Author Response for Submission “PushAround: Collaborative Path Clearing via Physics-Informed Hybrid Search”

Summary of the revision

To Associate Editor

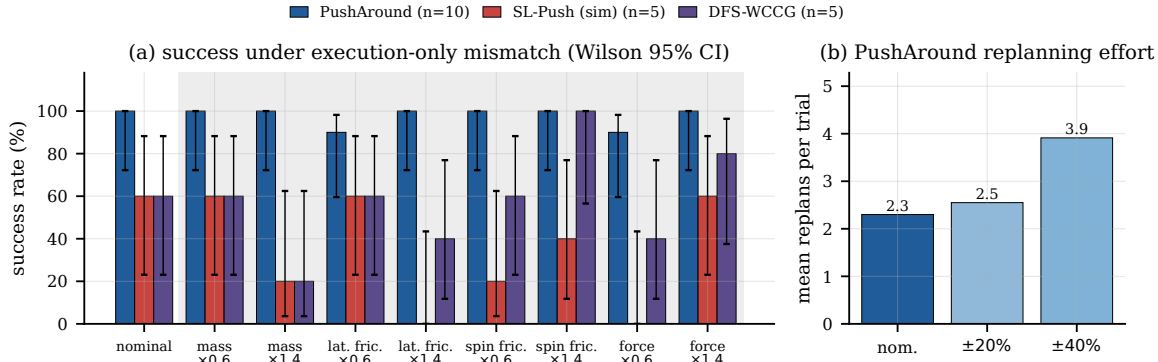
Q: *The method relies heavily on simulation-based feasibility validation, but sensitivity to uncertainty in mass, friction, force limits, contact dynamics etc. is not systematically evaluated.*

A: We agree that this was the most substantive gap, because physics validation is the distinguishing element of the method. The original hardware experiments demonstrated closed-loop recovery but did not *isolate* sensitivity to individual model parameters. The revision therefore adds a dedicated planner–execution mismatch study with two properties that make the claim falsifiable:

- **Mismatch, not retuning.** The planner always uses the nominal model; *only* the execution simulator is perturbed. The experiment therefore measures the consequence of an incorrect planning model rather than the benefit of re-identifying it.
- **One family at a time, paired seeds.** Obstacle mass, lateral friction, spinning friction and the robot force limit are scaled separately by $\{0.6, 0.8, 1.2, 1.4\}$, i.e. $\pm 20\%$ and $\pm 40\%$, using the same scene seeds as the nominal condition.

Result. Over 17 conditions ($M=30$, $N=2$, 10 seeds each, 170 trials) PushAround succeeds in **166/170 (97.6%)**, and importantly the success rate does *not* degrade with the perturbation magnitude: **78/80 (97.5%)** at $\pm 20\%$ and **78/80 (97.5%)** at $\pm 40\%$, versus 10/10 nominal. The four failures are one mid-execution planning failure (lateral friction $\times 0.6$) and three trials that exceeded the per-trial budget (spin friction $\times 1.2$, force limit $\times 0.6$ and $\times 1.2$). Replanning absorbs the remainder: mean replans rise from 2.3 (nominal) to 3.9 ($\pm 40\%$ average; up to 8.1 under force limit $\times 0.6$), where the weaker pushing force shortens the reachable force range and lengthens execution from 104.7 s to 159.6 s.

Baseline comparison (added in this revision). To show that this robustness is a property of the method rather than of the scene, we ran SL-Push (sim) and DFS-WCCG under the same protocol

(nominal planning, execution-only perturbation, 5 seeds per condition). Under the identical $\pm 40\%$ perturbations, SL-Push (sim) attains **13/40 (32.5%)** — with 0% under lateral friction $\times 1.4$ and force limit $\times 0.6$ — and DFS-WCCG **23/40 (57.5%)**, while requiring $\sim 12\times$ more planning time (mean 229 s versus 18 s). Both baselines are already weaker at nominal physics (3/5 each versus 10/10), which is consistent with the main comparison in Table II.

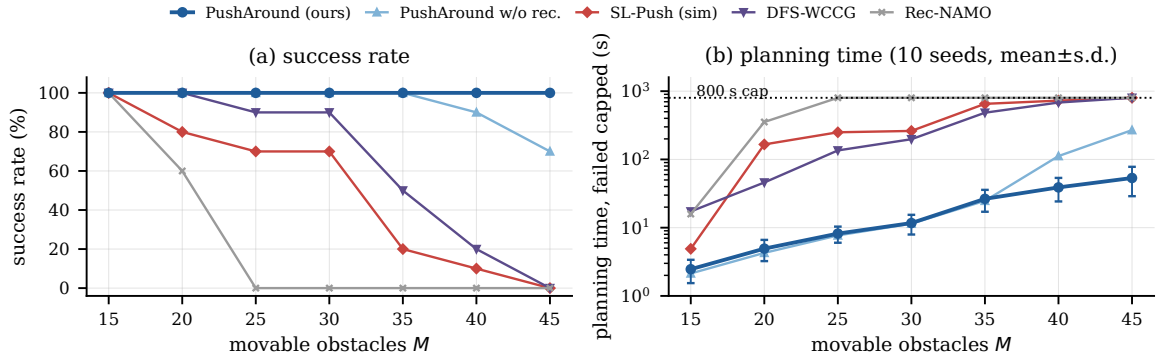
Q: *Although the method is tested with up to 45 movable obstacles, the number of independent trials is limited.*

A: We agree, and we have both increased the number of independent runs and changed how the results are reported.

- **Seeds.** The density sweep now uses **10 independent seed sequences** per density instead of five (7 densities $\times$ 10 seeds = 70 PushAround trials). For each seed the denser instances are

generated incrementally, while different seeds are generated independently, so the success-rate estimates at neighbouring densities are paired but the seeds themselves are not.

- **Dispersion, not only means.** Fig. 9 now shows the success rate and the mean planning time with one-standard-deviation whiskers; Table III lists PT and ET as $\text{mean} \pm \text{s.d.}$. Failed and pruned baseline trials are assigned the 800 s cap before averaging, and the failure composition (plan failure vs. timeout vs. timeout-pruned) is reported per density in the appendix tables.
- **Confidence.** All headline success rates are reported with Wilson 95% intervals in Fig. 5. For PushAround at $M=45$ the interval is $[72.2, 100]\%$ from 10/10; for the baselines at the same density it is $[0, 27.8]\%$ from 0/10.

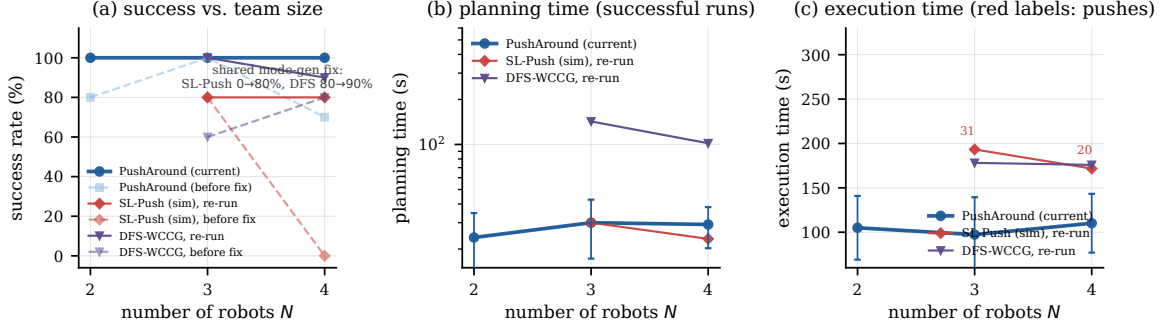
Q: *The experiments primarily use two robots. What happens when the number of robots increases with the complexity of the task? How does the search and the contact/force formulation scale to larger robot teams?*

A: This question turned out to be more productive than expected. It exposed a mode-generation bottleneck, we fixed it, and the re-run — performed on *both* PushAround and the baselines with identical code — shows that the fix lives in the shared mode generator rather than being a PushAround-only behaviour. The corrected comparison is reported below.

(a) Complexity. The implementation never enumerates joint contact tuples. With $|\mathcal{A}|$ reachable contact candidates per robot, exhaustive assignment would require $|\mathcal{A}|^N$ tuples; instead one greedy replacement sweep tests at most $N|\mathcal{A}|$ single-contact substitutions, each solving the force LP whose decision vector has dimension $2N$. Larger teams therefore enlarge the feasible wrench set but also increase contact-assignment and LP cost. Sec. III-E2 states this explicitly.

(b) Bottleneck, fix, and who benefits. The preliminary $N=4$ runs failed in 3 of 10 seeds (2 planning failures, 1 budget timeout). Diagnosis: for some push tasks *no* full-team contact assignment exists — small pushable faces, or the pairwise pusher-clearance constraint rejecting every remaining candidate of one robot — and the legacy greedy replacement was additionally sensitive to robot ordering. We added two mode-generation-local refinements that leave global planning, task sampling and the search tree unchanged: (i) *bounded backtracking* contact assignment and (ii) a *temporary per-task robot release* (up to one robot is excluded for that single push and holds its pose, a penalty is charged during mode ranking so full-team modes are preferred, and the full team is re-available for every later task).

Both refinements sit in the shared mode generator, so the baselines inherit them too — which is why the baseline cells were re-run on the same code. Instrumenting the 40 baseline trial logs (4 cells $\times$ 10 seeds) counts 20,890 failed greedy replacements, 10,904 backtracking assignments (rescuing 739 of them) and 6,017 per-task robot releases. The effect is therefore not PushAround-specific:

(c) Revised conclusion. After the fix, all three methods solve 80–100% of the team-size trials, so *we no longer claim that the baselines degrade with team size*, and the success-rate differences at $N=3, 4$ lie within overlapping Wilson intervals (at $N=4$: PushAround $[0.72, 1.00]$, DFS-WCCG $[0.60, 0.98]$, SL-Push (sim) $[0.49, 0.94]$). What remains separated is (i) *consistency*: PushAround is the only method with 30/30 successes over $N=2, 3, 4$; and (ii) *efficiency*: 24–30 s of planning and 97–110 s of execution versus 102–143 s and 172–193 s for DFS-WCCG (whose planning-time standard deviation reaches 183 s at $N=3$), and 10–11 pushes versus 20–31 for SL-Push (sim). The manuscript states this narrower claim rather than a monotone team-size trend.

Figure 4: WCCG validation. (a) Agreement per category: CC and FR differ on 4 of 300 scenes (all raster-unstable), whereas WCCG matches the continuous reference on all 300 with zero false positives/negatives. (b) Mean connectivity-query cost on a logarithmic scale.

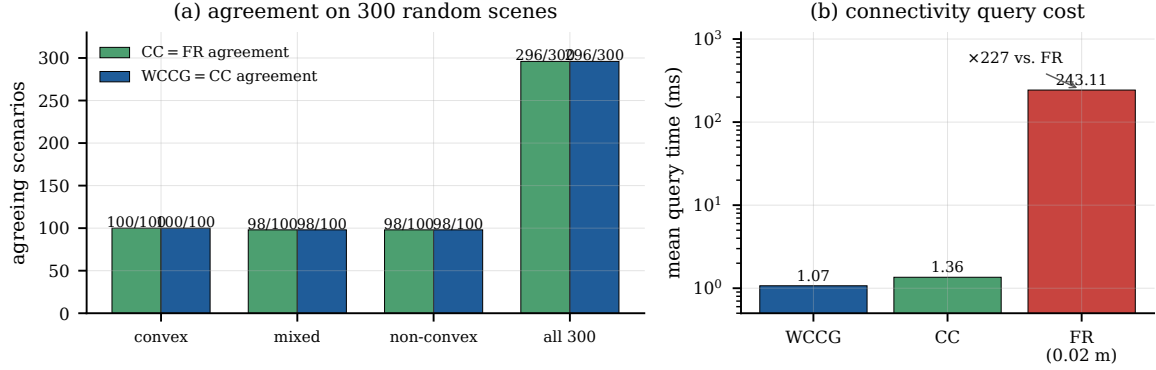
Q: *The WCCG connectivity condition is important since it is used throughout the search and also determines termination ... the paper would benefit from a little more justification here, or perhaps a comparison with a standard configuration-space connectivity check. This seems especially relevant when the obstacles are non-convex.*

A: We agree, and we provide both a derivation and the suggested empirical check.

(a) Why the same-face test is the right query. For a vehicle whose footprint is enclosed by a disk of radius $W/2$, inflating every obstacle boundary by $W/2$ turns any pair of boundary components whose closest distance is below W into *overlapping* barriers in the configuration space of the vehicle centre. A WCCG bridge–bridge edge records exactly such a non-traversable bottleneck, and centroid–bridge edges attach the bottleneck to the adjacent free regions. Consequently, “start and goal lie in the same planar face” is equivalent to connectivity in the complement of the inflated geometry, i.e. to the W -clearance condition. Non-convex obstacles require care, which is why the construction first performs a clearance-relevant convex decomposition and then inserts bridges between the resulting components/segments.

(b) Empirical validation on 300 scenes. Because degenerate geometry and decomposition choices still matter in practice, we also compare WCCG against two independent references on 300 random scenes stratified into convex, mixed, and non-convex obstacles: a continuous configuration-space (CC) reference and a rasterized reference (FR) at 0.02 m, verified at 0.01 m. CC and FR disagree in **4/300** cases, all of which are raster-unstable near narrow or tangential contacts. On all 300 scenes, WCCG agrees with the continuous reference and produces **zero false positives and zero false negatives** — a false positive would be the dangerous case, as it could terminate PIHS prematurely. WCCG additionally answers a query in **1.07 ms** on average, comparable to CC (1.36 ms) and **227×** faster than FR (243.1 ms), while supplying the gap graph that PIHS consumes.

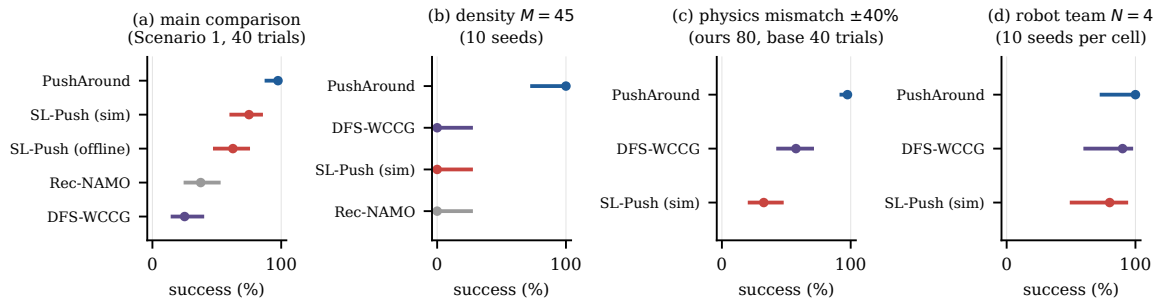
Q: *A few more implementation details, such as robot reachability checks, timeout limits, and computation budget, would make the comparison easier to interpret. I would also suggest adding error bars or standard deviations, particularly for the scalability experiment where only five seeds are used for each obstacle density.*

A: We have made the protocol explicit and now report dispersion throughout. The full protocol is summarized in Table 8.

- **(Pages 4 and 6, Secs. III-C2 and IV-A1) Reachability.** A contact candidate is retained only if the associated pre-contact pose is collision-free and the transition planner can reach it from the current robot configuration; a multi-robot tuple is rejected if any assigned robot fails this check. All compared methods use this same check, together with identical footprints, obstacle realizations, success criterion, and execution simulator.

- **(Page 6, Sec. IV-A1) Budgets.** All suites use a per-trial timeout of **800 s**, a cap of **20,000** control steps, and **8** parallel workers; plan failures, timeouts and timeout-pruned trials are assigned the 800 s value before averaging planning times, and the failure composition is reported per condition.

- **(Pages 6–7, Secs. IV-A1 and IV-A6) Statistics.** The density sweep, the robot-team study (all policies) and the mismatch study for PushAround use 10 seeds per cell; only the *mismatch* baseline supplements use 5 seeds and are labelled as such. Fig. 5 reports Wilson 95% intervals for every headline number, and Table III in the manuscript reports $\text{mean} \pm \text{s.d.}$

- **(Page 6, Sec. IV-A1) Correction.** The original manuscript stated a 400 s cap; the stored logs use 800 s, and the revision corrects this.
